TO: Planning and Zoning Commission
FROM: Evann Martin, Assistant Planner
DATE: August 4, 2020
RE: Hy-Vee Fast & Fresh – Site Plan

RE: Hy-Vee Fast and Fresh Site Plan (SE 37th and Hwy 141)

The Development Services Department is in receipt of a proposed Site Plan for Hy-Vee Fast and Fresh. Based on the review of the provided submittal materials, staff have the following comments:

GRADING PLAN

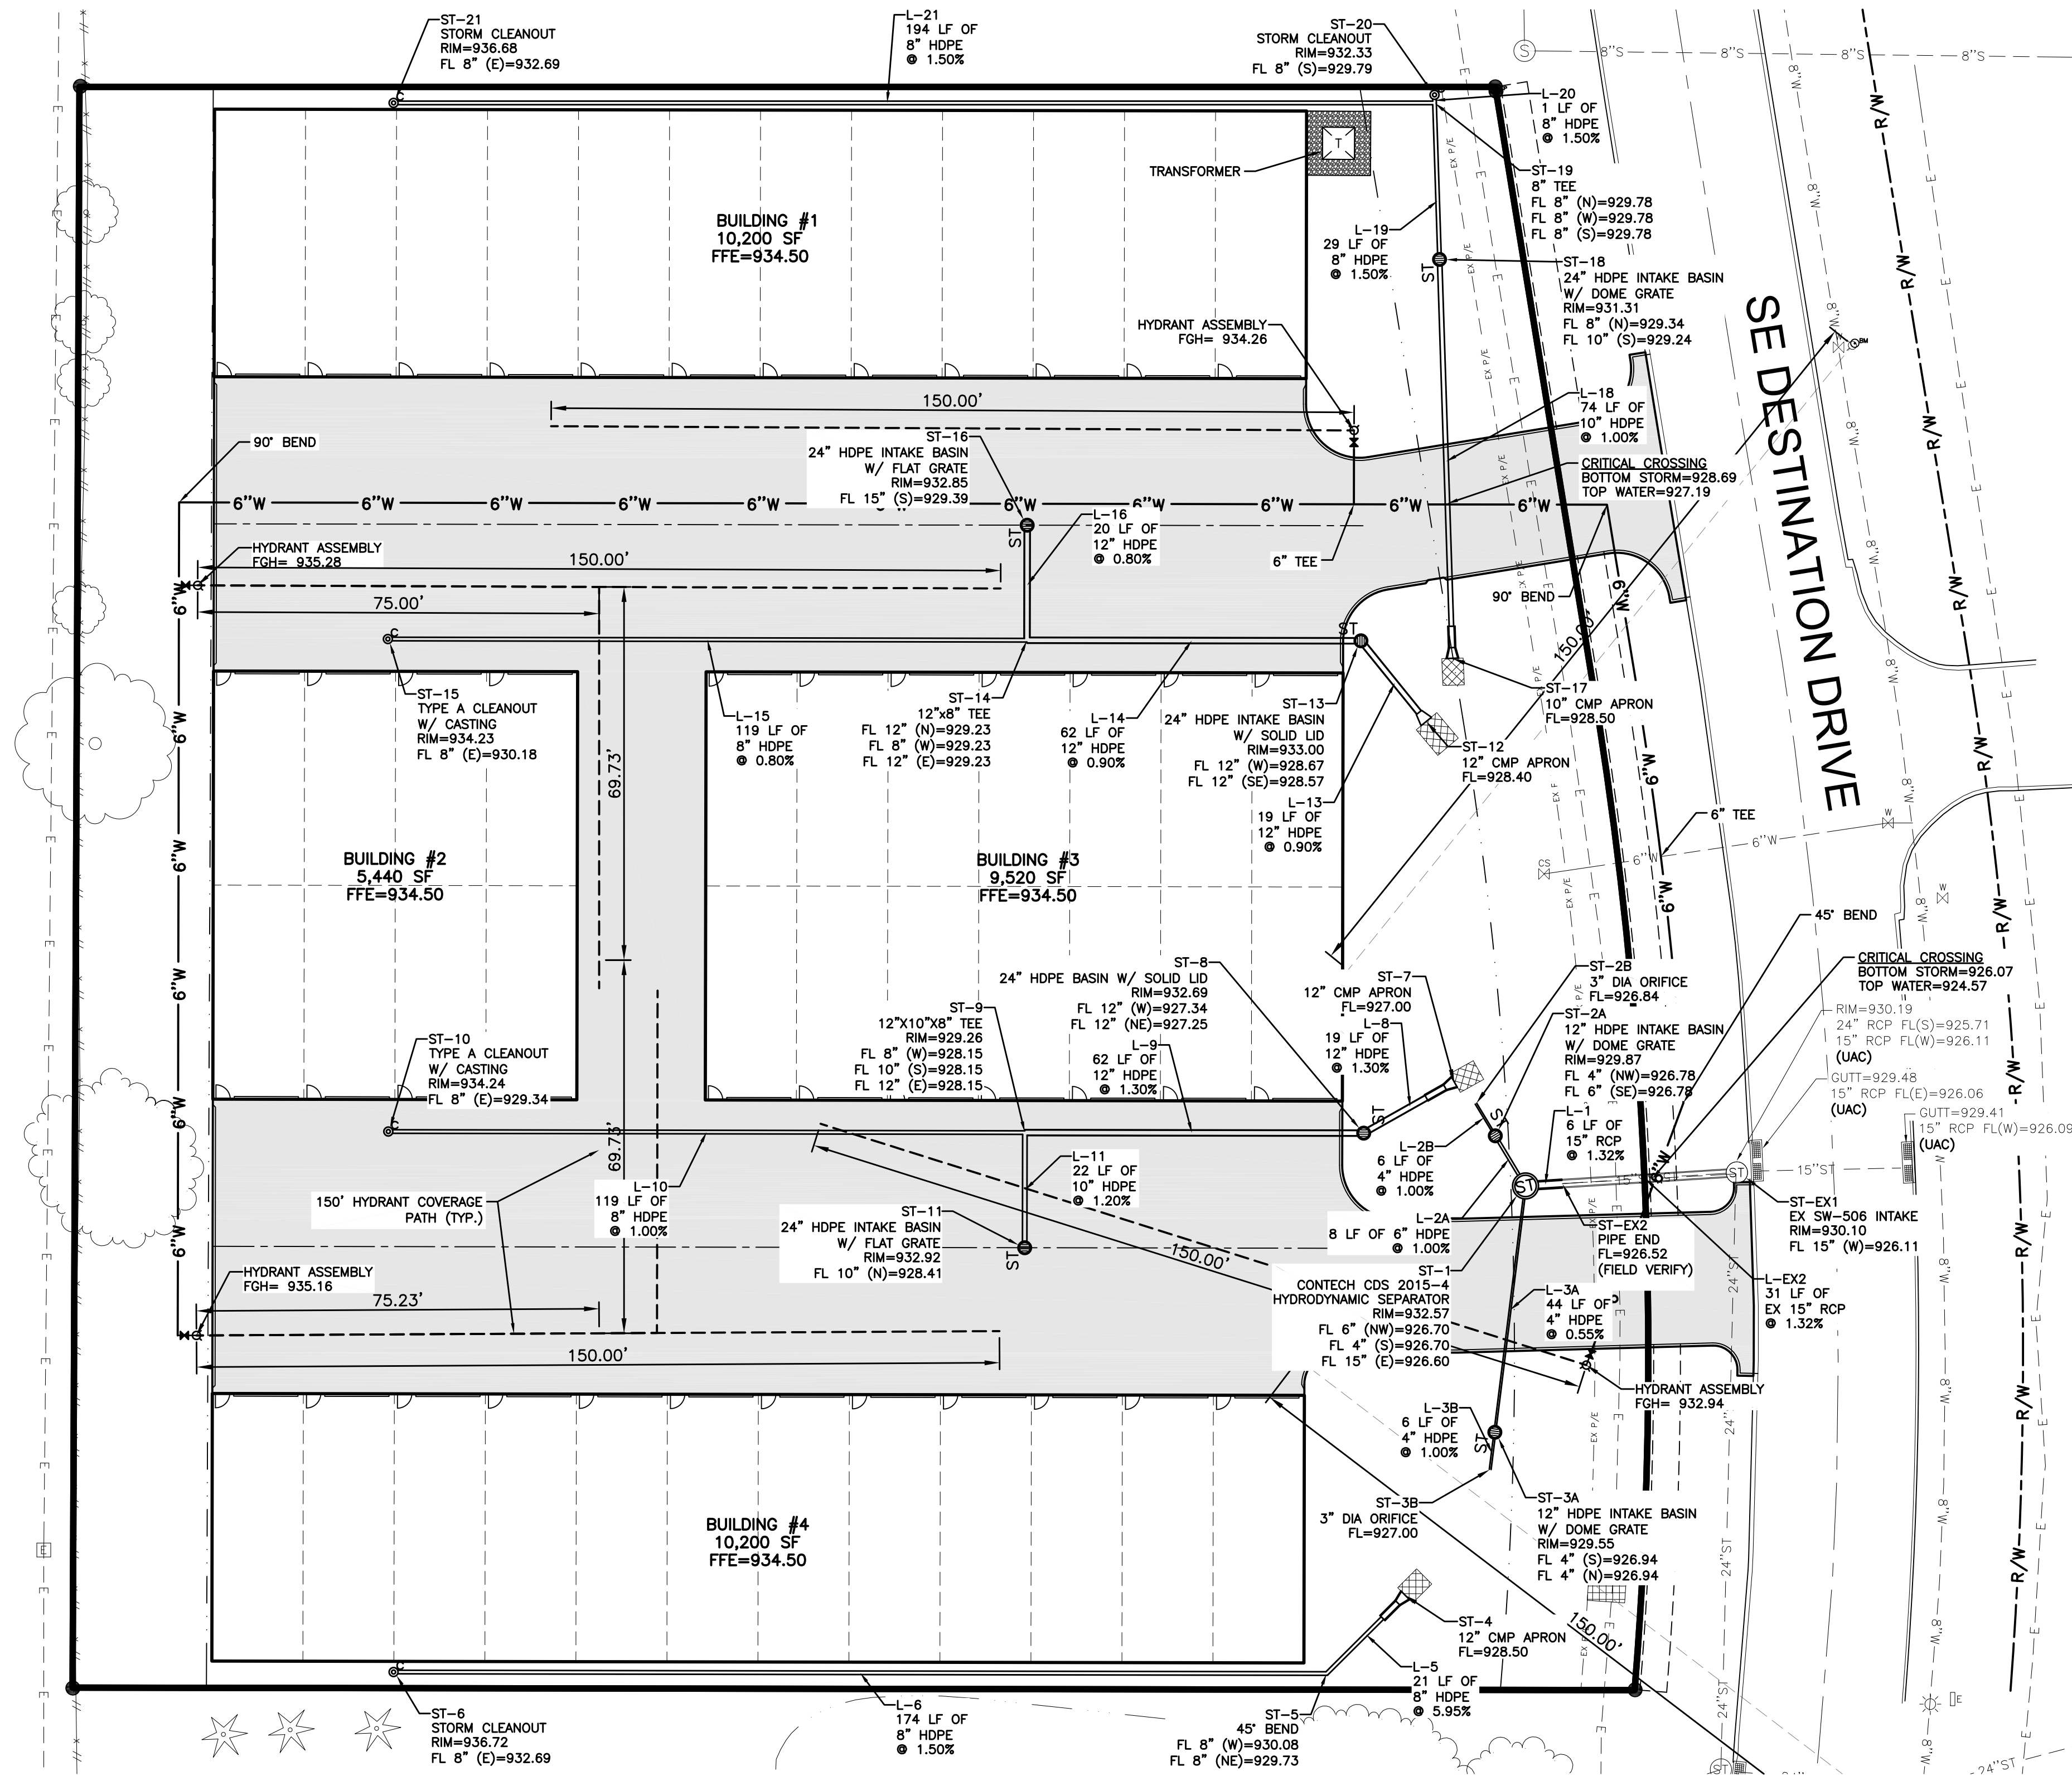
8. Sheet 3 of 7: The north driveway appears to have a high point elev = 933.74-ft. by which water would escape the parking lot should intake ST-16 become plugged. Provide 1-ft. of freeboard in this area of the site.

Mega Storage
Elevation - Building 1

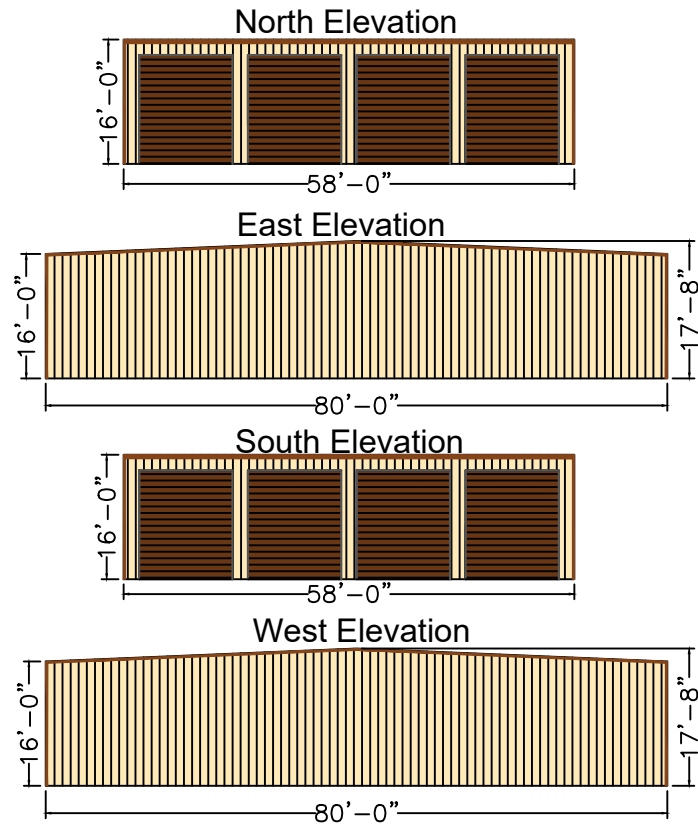
1. Provide a list of materials and colors.

2. Commercial buildings shall incorporate façade modulation in all building elevations, either by physical offsets or by the use of color, pattern, or texture in order to preserve building scale and reduce the negative aesthetic impact of long, large, expansive wall surfaces. Please add additional features of the east elevation such as windows, awnings, paint design, etc. **The standards were put in place to enhance building construction outside of the overlay districts. The buildings in the area were approved prior to the architecture standards. Additional features, such as awnings, paint design, additional stone, etc. need to be added.**

3. Commercial buildings shall incorporate architectural design elements, materials, and colors into the side and rear building elevations similar to those used in the front building elevation. **The architecture standards were put in place after the existing buildings in the area and are meant to enhance building design. Please provide.**

- ~~4. Any roof mounted equipment must be screened. Please show screening on the elevations, if applicable.~~
- 5. Please show proposed wall pack lighting on the building elevations.**

6. A minimum of 25% of the building frontage and a minimum of 30' along the adjacent sides shall be stone/masonry. Please add building material calculations and dimensions to the elevation sheets. **This is a code requirement so the stone needs to be added on the sides. The standards were put in place to enhance building construction outside of the overlay districts. The buildings in the area were approved prior to the architecture standards.**
